Atlantic Coast Pipeline and Supply Header Project *Final Environmental Impact Statement*

Docket Nos. CP15-554-000, CP15-554-001, CP15-555-000, and CP15-556-000
 FERC/EIS-0274F

APPENDIX Z COMMENTS ON THE DRAFT ENVIRONMENTAL IMPACT STATEMENT
AND RESPONSES

Figure 1. Calculation of the Fragmentation Factor Variable in the Core Integrity Impact

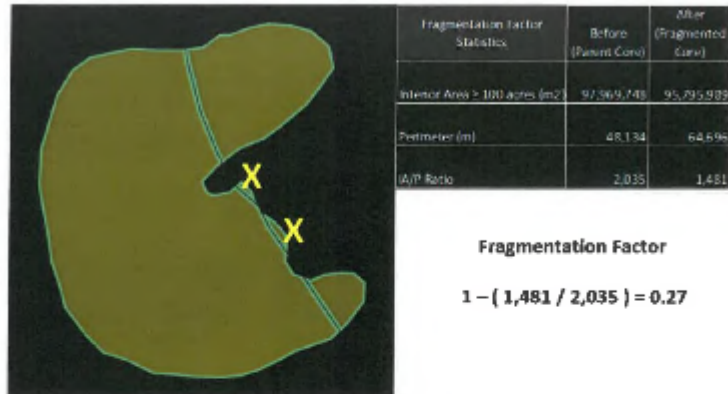
Figure 1 provides a representative example that illustrates the Fragmentation Factor calculation of the overall Core Integrity Impact for a single core. All area calculations were conducted in square meters to retain precision, and later converted to acres. Interior area is the area of the parent core minus the 100 meter transition zone to existing non-forest vegetation cover. In this example, when the parent core is intersected by the pipeline, two smaller cores (upper right and lower right lobes) are created, as well as two non-core fragments, which are considered lost and no longer meet the criterion for 100 acres of intact interior. The fragmented core interior area is the sum of all the remaining areas meeting the 100-acres of intact interior criterion. The before-impact perimeter is the overall perimeter of the parent core and the after-impact perimeter is the cumulative perimeter all the resulting fragments. The IA/P ratio is calculated by dividing the interior area by the perimeter for each core.

Figure 2. Calculation of the Depth Factor Variable in the Core Integrity Impact

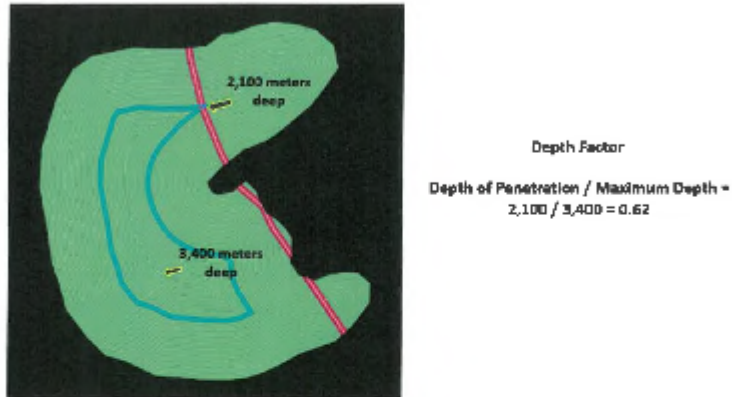
Using 100-meter inward buffers of the outmost pre-impact parent core perimeter, the maximum depth of every core was calculated via measurement to the most central ring. In the representative example provided in Figure 2, the maximum core depth is 3,400 meters. Likewise, the depth of penetration of the pipeline was also measured at the deepest point of penetration; 2,100 meters in the Figure 2 example. The Depth Factor was then calculated as the proportion of overall depth that is penetrated by the pipeline, and thus represents the

Figure 2. Alternative route analyzed by DEQ for ACP near the Elizabeth River.

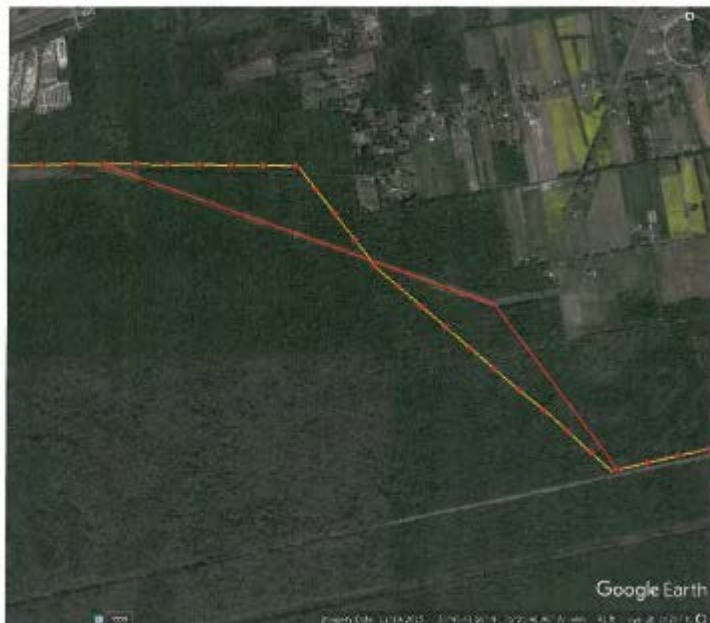
- oxygen, and aquatic plants. There are no known sources of PCBs that will be affected by the construction of the pipeline across these two water bodies.
- The final mile of the proposed pipeline construction crosses the Elizabeth River between Mileposts 81.8 and 82.0 parallel to the Military Highway drawbridge. The river is impaired for PCBs in fish tissue, as well as presence of dioxin and poor dissolved oxygen. The route appears to avoid documented point sources in this region; however, there is one opportunity to align the pipeline route better with an existing major power line easement. This alternative route will decrease the pipeline by approximately 0.05 miles, and reduce the loss of forested corridor by 1.35 miles. Figure 2 illustrates an alternative route that takes advantage of the existing power line easement that the ACP route already follows in part.

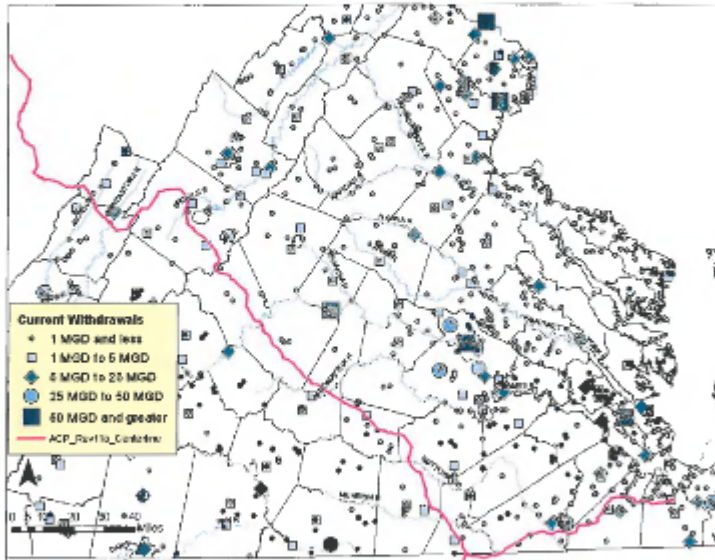
- Groundwater and surface water withdrawals in Virginia are depicted in the map below. It is evident the pipeline will be in close proximity to many of these sources. Dominion should communicate with water withdrawers regarding the construction, water withdrawal, and other activity that may impact the facilities.
